**From:** [REDACTED]  
**To:** [Norfolk Boreas](#)  
**Subject:** Deadline 14 Submission  
**Date:** 25 August 2020 14:47:01  
**Attachments:** [Boreas Plans Monday 24 08 20.doc](#)  
[Windfarm plans.zip](#)

After having these printed, on review I am still not assured of the safety of the proposed HIS. I have responded with further considerations and questions to Vattenfall today and attach all for your reference. I would strongly draw your attention to drawing TP -PB5640-DR066

PROJECT  
**NORFOLK BOREAS  
 OFFSHORE WIND FARM**

DRAWING No. TP-PB5640-DR067  
 REVISION  
 CLIENT DWG No. F1.0

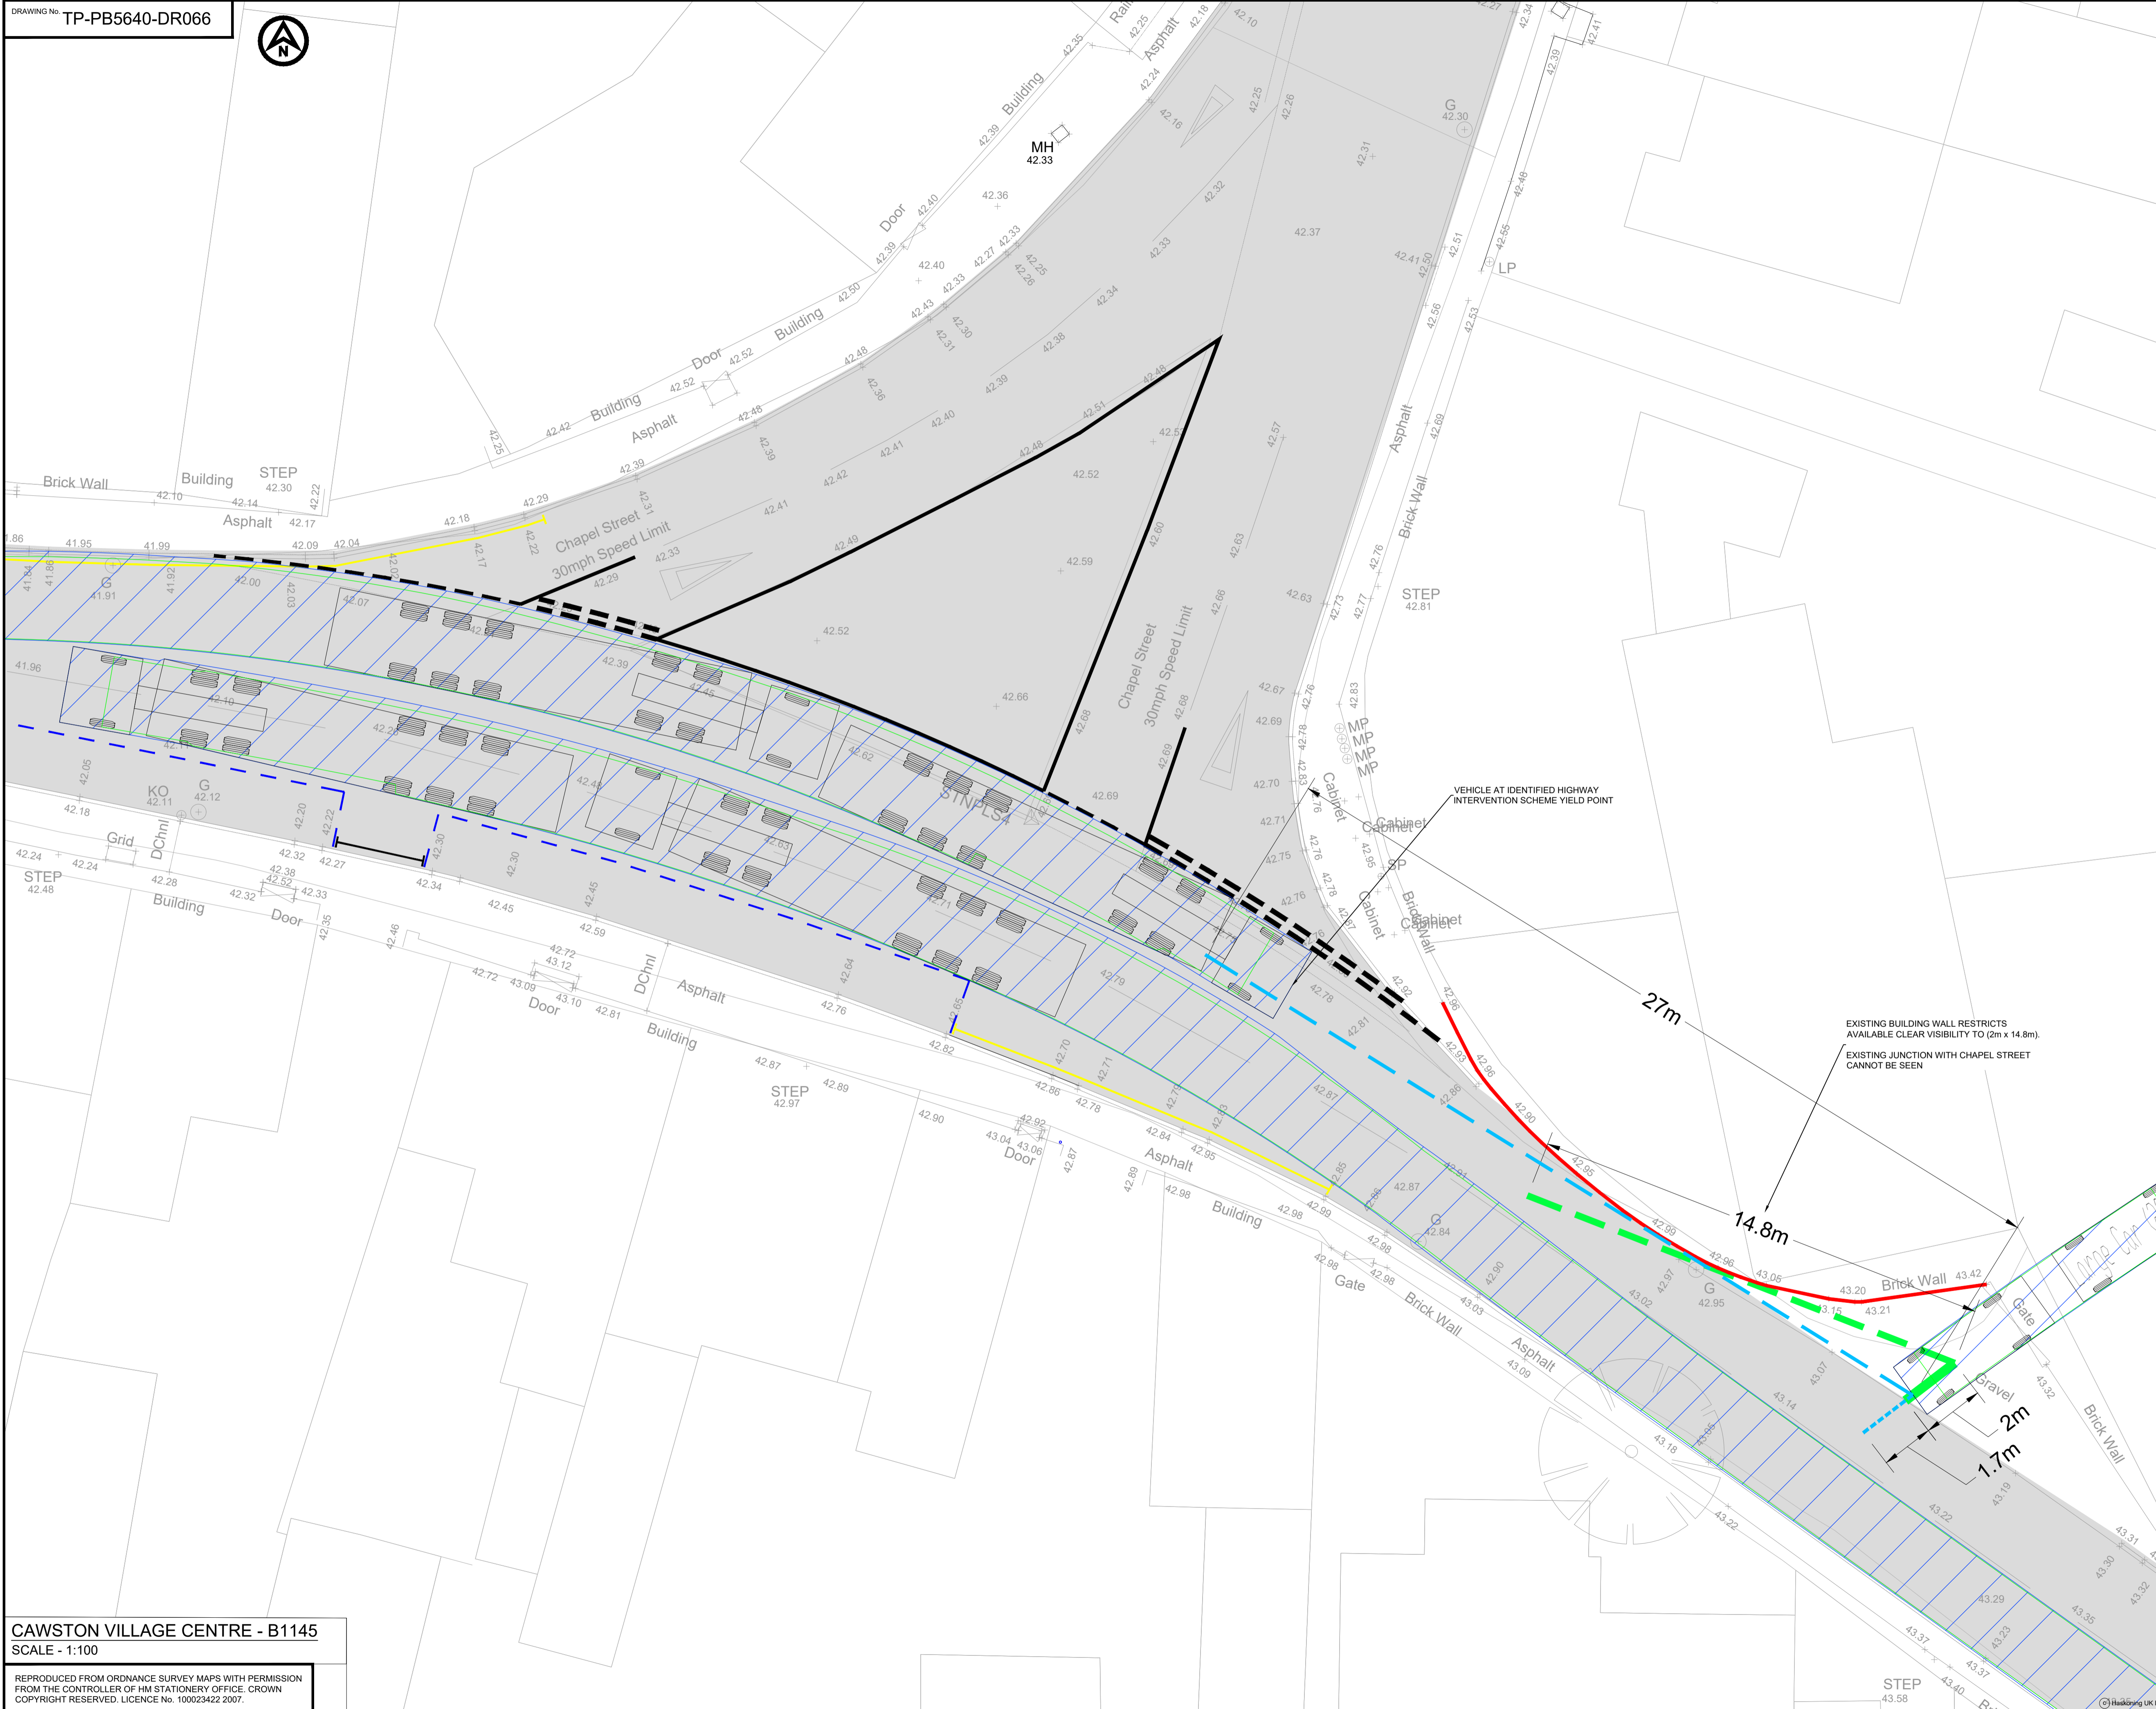
This drawing shows **existing** visibility stating I currently have to come into the road by 1.7m to see a HGV travelling east. Currently I rarely see HGVs travelling in this direction, it must be acknowledged that traffic is far less than proposed and currently "larger" vehicles, i.e tractors or buses will travel down the centre of the road and I am able to see these way down the High Street before pulling out to any significant distance.

Please note the blue parking bays detailed on this plan are overstated. Vehicles do not park directly opposite the Chapel Street access way because of the turning circle required by the winery lorries.

This existing visibility drawing shows a bus driving west past my property. It is drawn as actual, taking that required road position slightly over the centre line to get the angle to drive down the High Street and avoid pedestrians on the one sided narrow pavements.

DRAWN	RNE	CHECKED	ADR	APPROVED	ADR
DATE	29.07.2020	SCALE AT A1	1:100	CLIENTS REF.	
DRAWING No.	TP-PB5640-DR066	REVISION			
CLIENT DWG No.					F1.0

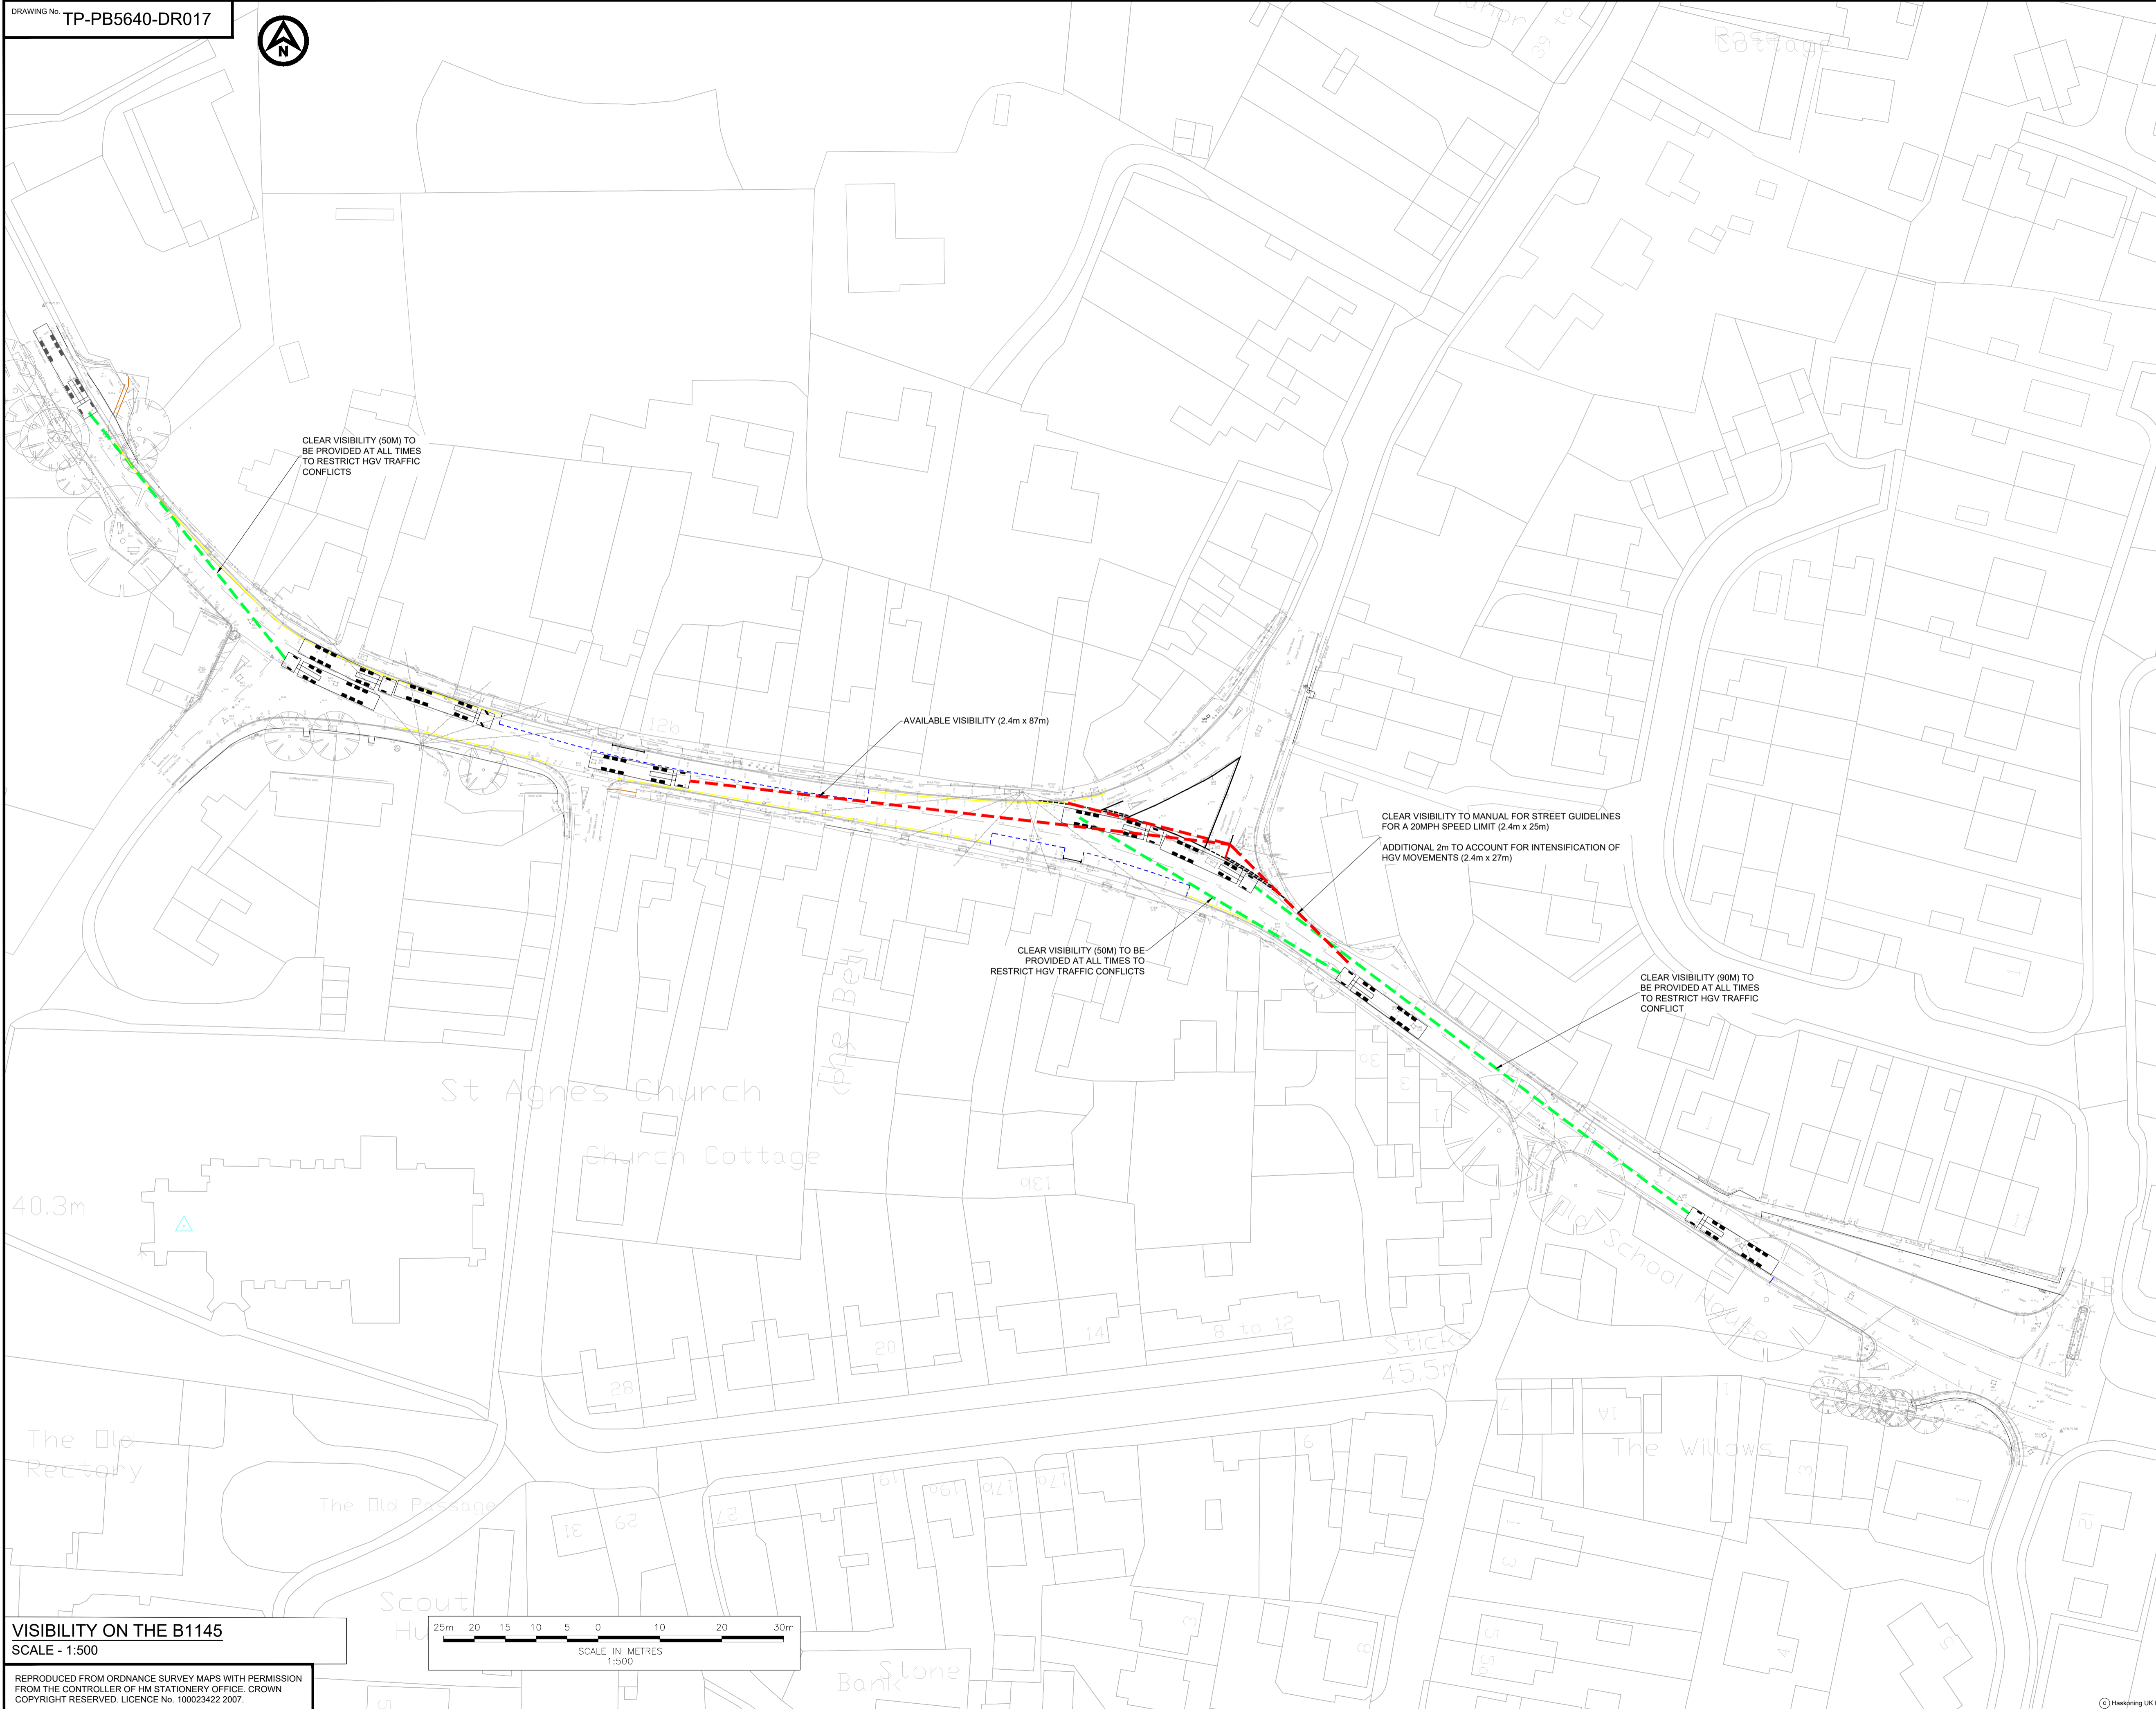
1. For an indication of how far I will need to travel into the road to gain sight of a yielded vehicle
2. For position of the yielded vehicle in relation to the access/ exit of Chapel Street
3. The travel path as drawn which denotes the HGV travelling west is actually riding against the kerb

With the HIS in place the HGV driving west past my property is drawn riding the kerb. A 90cm pavement against a high wall. If the HGV is placed in the same position from the kerb as the bus in DR067 and adding the width of wing mirrors into the equation there is conflict

with my proposed forward position. The HGV at the triangle yield position will not be able to see beyond either of us to see what is following, yielding.
